**Further information required to support planning application and under  
Regulation 25 of the Town and Country Planning  
(Environmental Impact Assessment) Regulations 2017:**

**Proposed Sand and Gravel Extraction on  
Land at White Cross Farm, Wallingford**

**Drainage Information Requested by Oxfordshire CC**

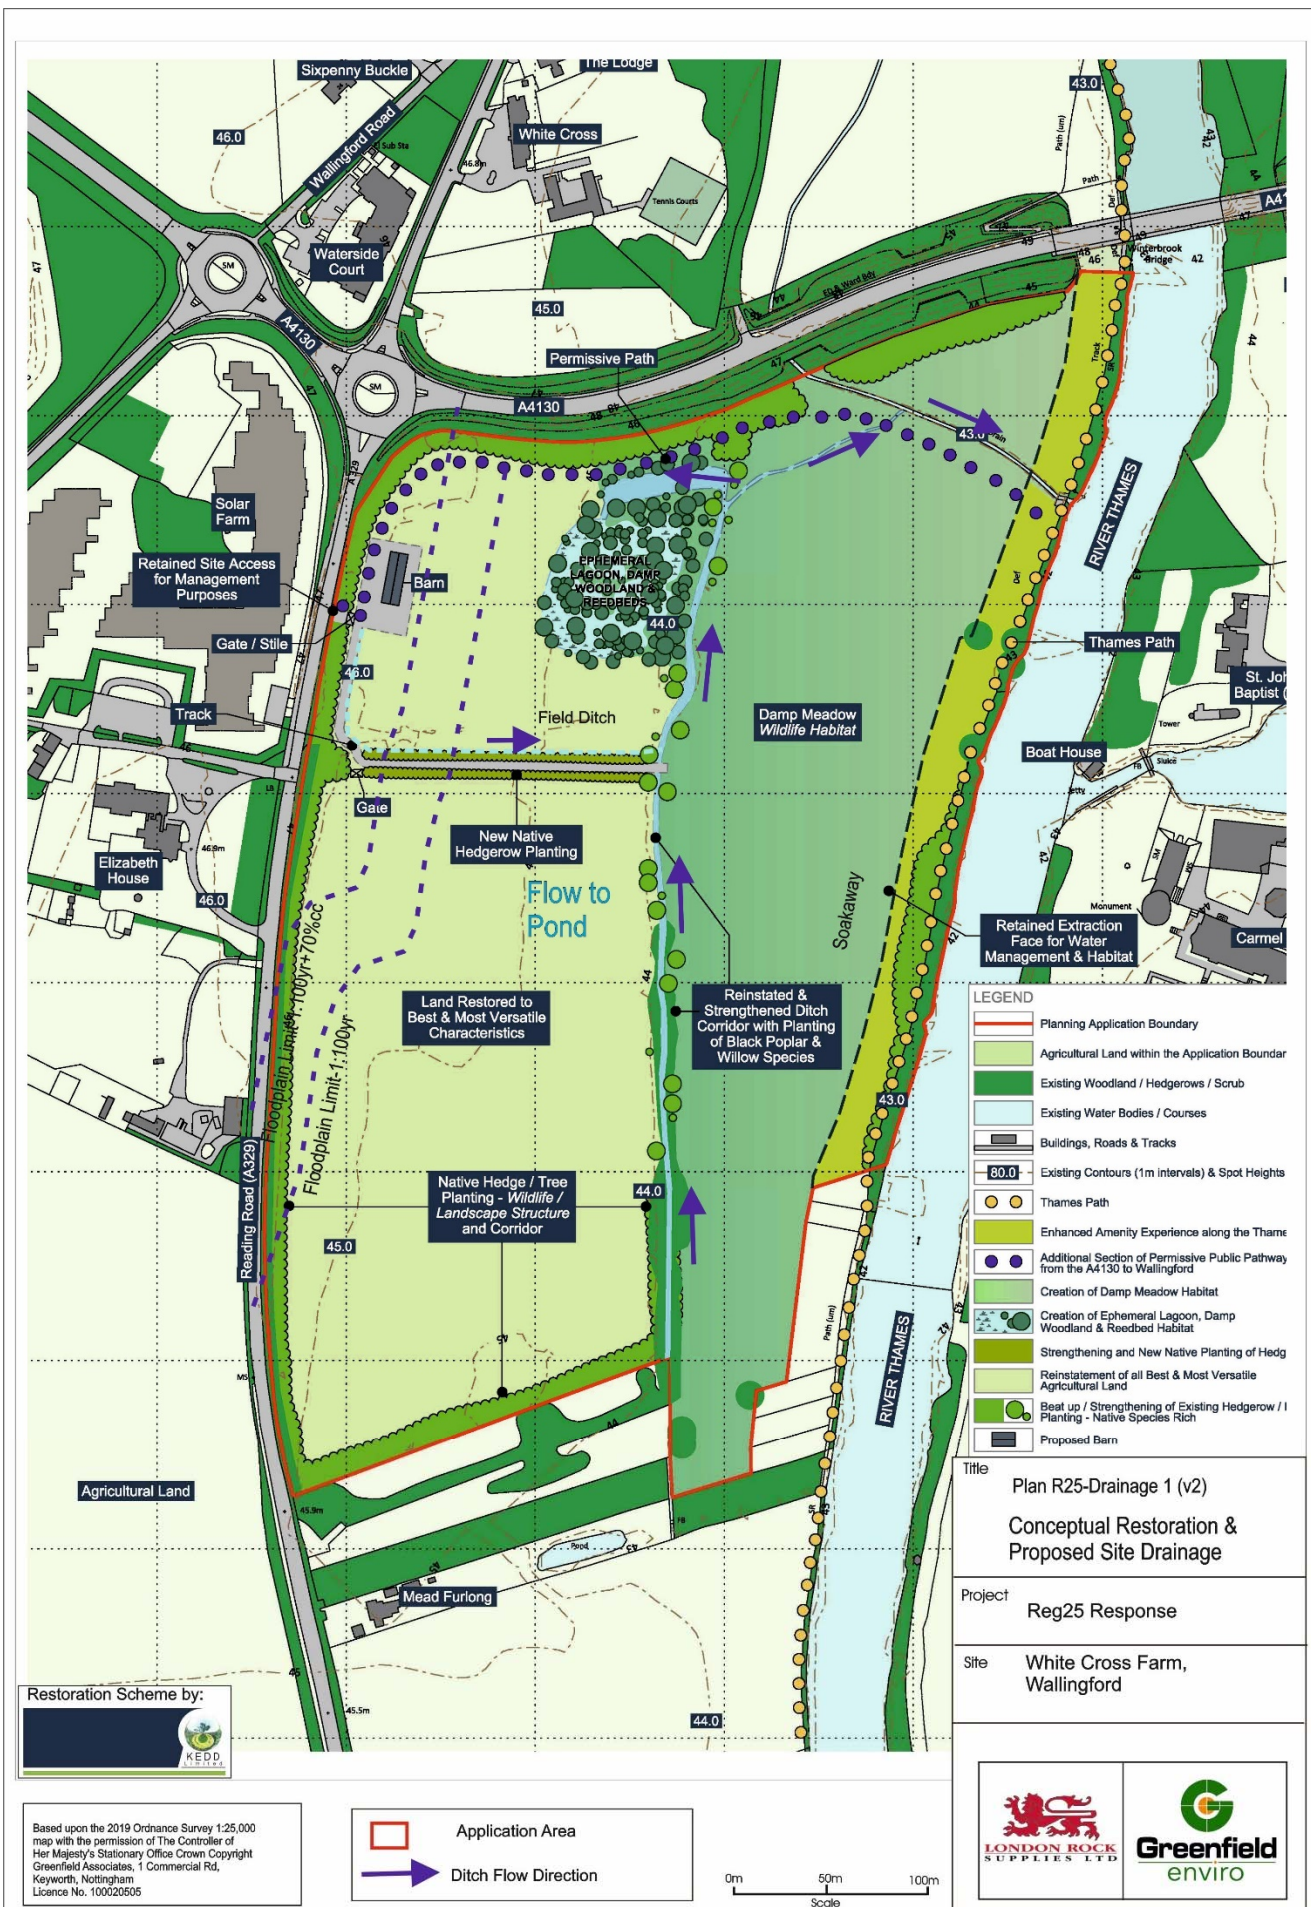
## **3. Calculation files demonstrating that surface water flow will be maintained to Greenfield discharge rates for all relevant return periods, including a 40% Climate Change allowance**

The restoration of the quarry site will be back to original levels, with the soils replaced to allow the existing mix of agricultural arable farming land and floodplain grazing grassland adjacent to the River Thames, with the additional habitats that are typical of the Thames Valley that increase the biodiversity of the site. These additional habitats include “damp meadow with shallow scrapes” together with ephemeral ponds, damp woodland and reed beds. The proposed restoration scheme is shown in Plan R25-Drainage 1 below.

The inclusion of a small lagoon/ pond in the areas of the silt lagoon will enhance the biodiversity of the scheme and also form a collection point for surface water run-off that will issue into the central (north-south trending) ditch. The southern part of this central ditch will be retained with the hedgerow and will be re-instated northwards in it’s original “pre-development” location and elevation.

The proposed restoration with the additional low-lying wetland areas, with the extended range of floodplain habitats, will increase the biodiversity of the site and also assist with the surface water drainage to reduce the discharge from the site compared with the current (pre-development) site.

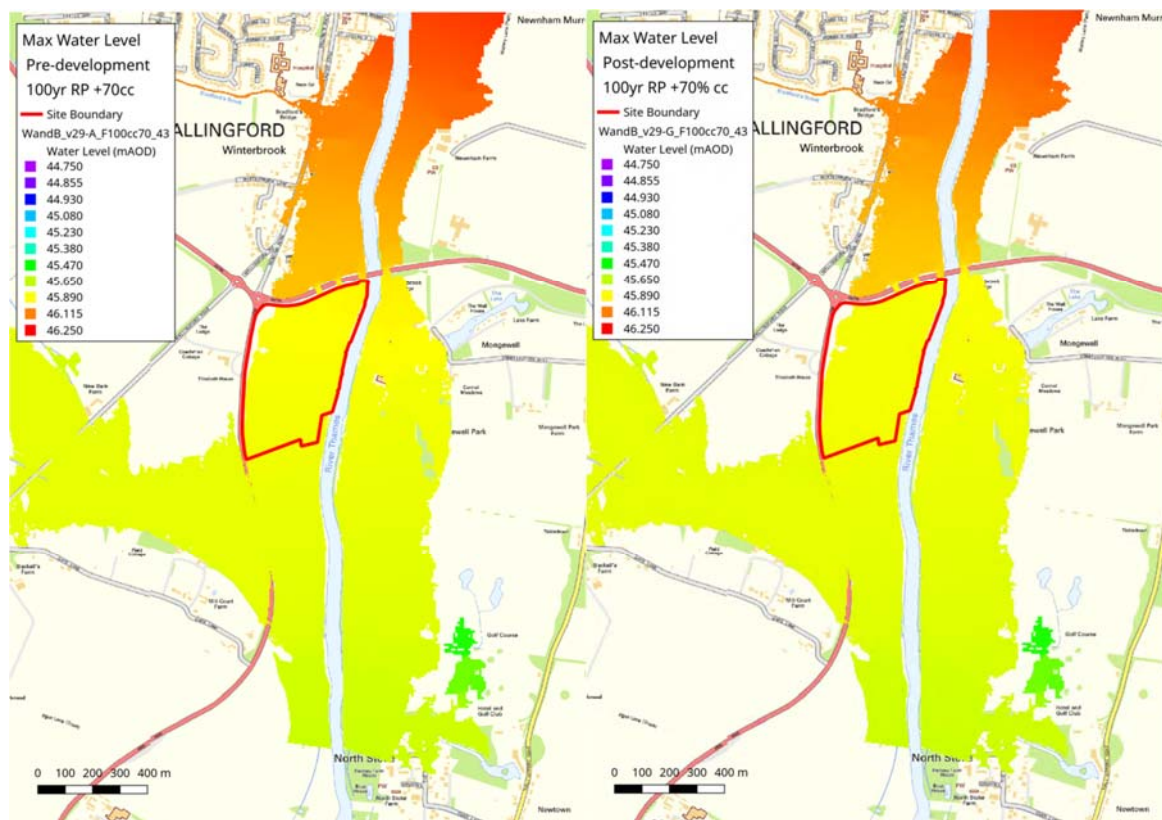
4. A plan showing where surface water flow paths will go once works to following restoration

The restoration scheme, with surface water flow paths are shown in Plan R25-Drainage 1 (above).
